Technical Service Information

THM 4T65-E RATTLING NOISE WITH ENGINE RUNNING

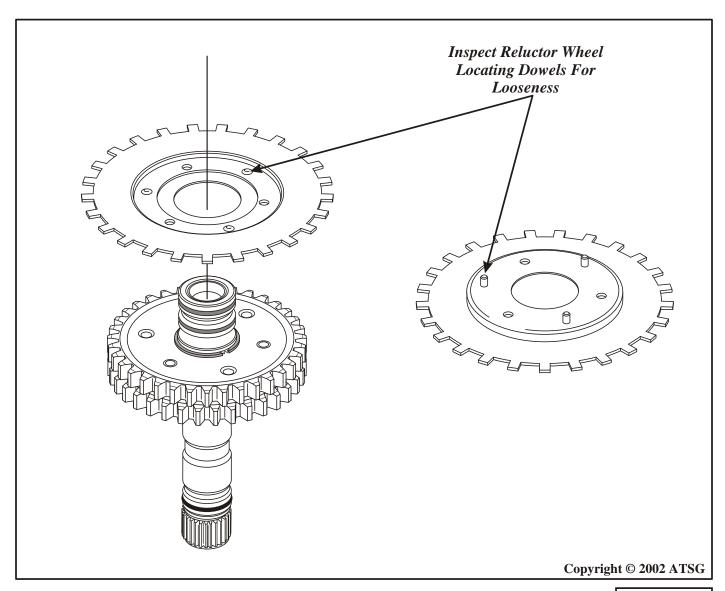
CAUSE: The cause may be, the locating dowels (rivets) being loose in the input speed sensor reluctor

wheel. Refer to Figure 1.

CORRECTION: Replace the input speed sensor reluctor wheel with updated OEM part number 24212217.
